Fargo VAMC – Refurbish Elevators and Replace Controls

Fargo, North Dakota
Project #19-2481

MARCH 26, 2024

ADDENDUM NO. 2

1 FLOOR PLAN - LIBERTY 1,2,3 - PIT
1/4" = 1'-0"

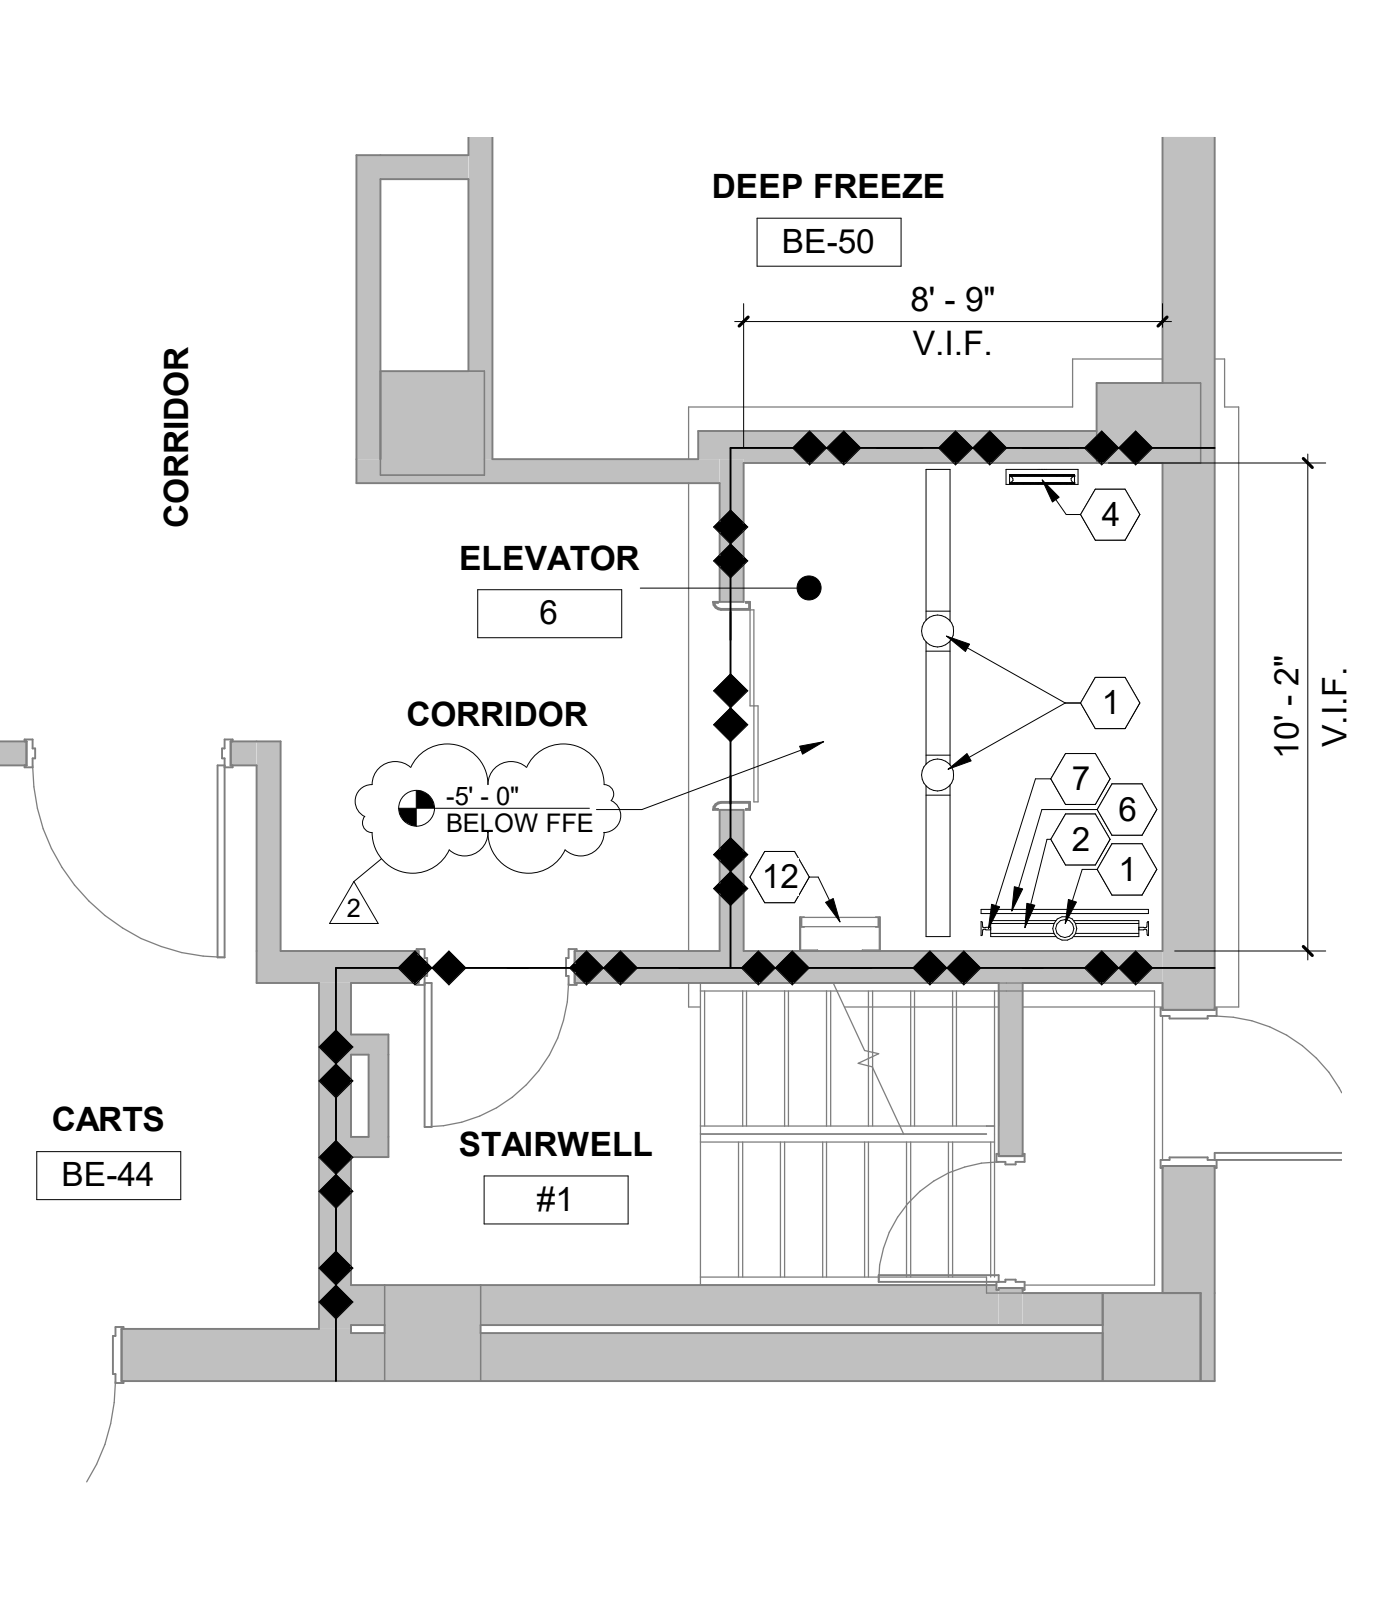
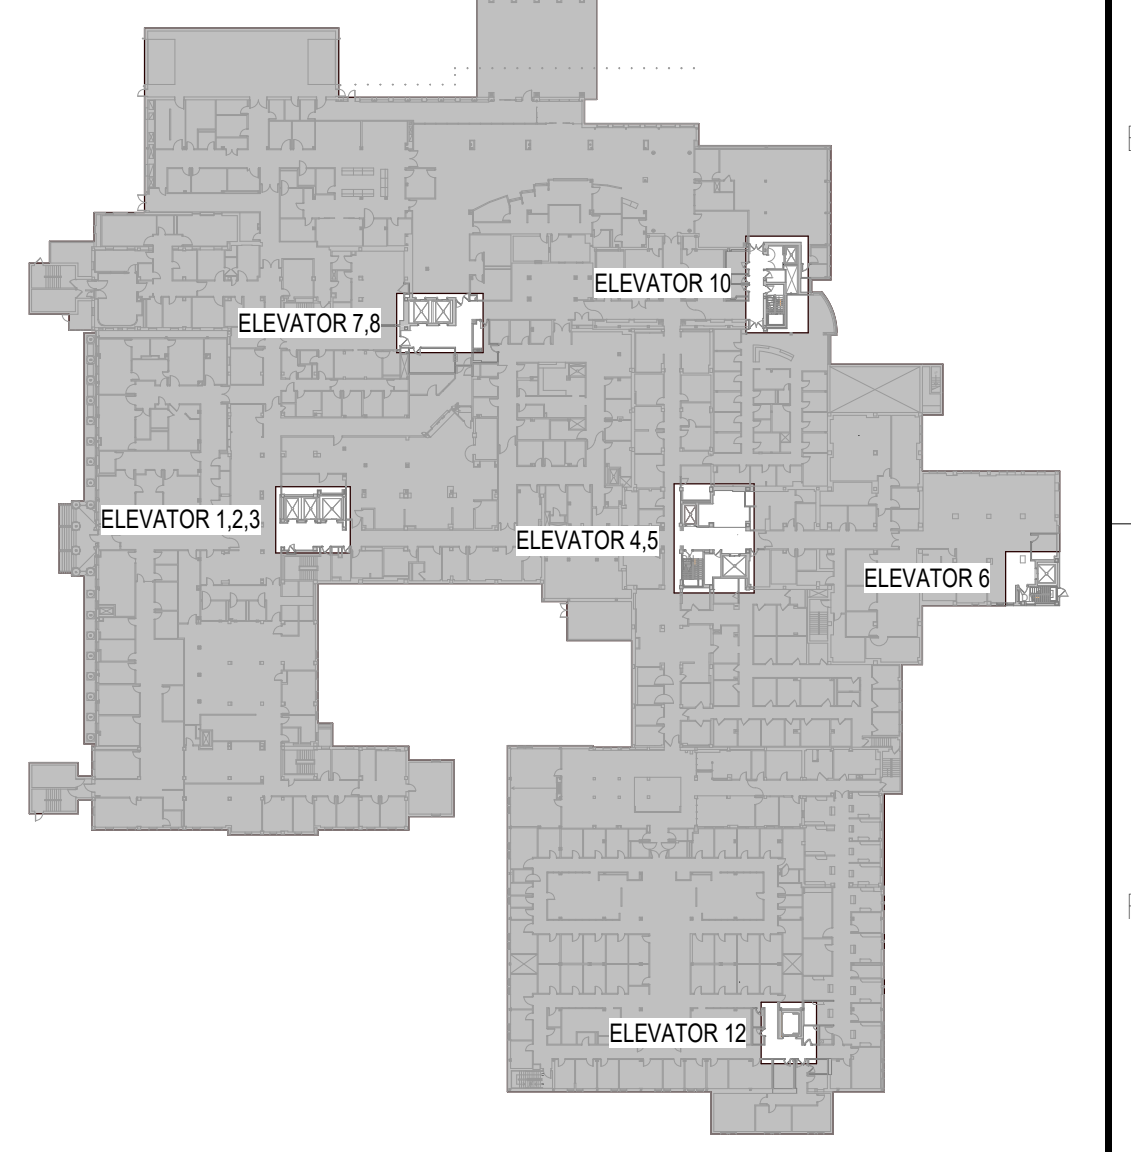
Drawing Sheet A5.20 ENLARGED PLANS – ELEVATOR PITS – See revised drawing sheet for the adjustment of keynotes # 3, 9, 15, 16, 17. Also included is the depth of each elevator pit relative to the floor elevation at the lowest elevator lobby for each hoistway.

11. RESILIENT TILE FLOORING. SEE SPECIFICATIONS.
12. NEW LOWER SECTION OF GUIDE RAILS (APPROX 20 LF AT EACH RAIL. INSTALL TO COORDINATE WITH OTHER NEW EQUIPMENT. PROVIDE NEW MOUNTING BRACKETS. APPLIES TO ELEVATOR 7 AND 8 ONLY DUE TO WATER DAMAGE.

13. NEW LOWER SECTION OF COUNTERWEIGHT RAILS (APPROX 20 LF AT EACH RAIL AND PIT GUARD. INSTALL TO COORDINATE WITH OTHER NEW EQUIPMENT. PROVIDE NEW MOUNTING BRACKETS. APPLIES TO ELEVATOR 7 AND 8 ONLY DUE TO WATER DAMAGE. EXISTING HYDRAULIC PISTON JACK TO BE REUSED. REPACK ENTIRE ASSEMBLY.
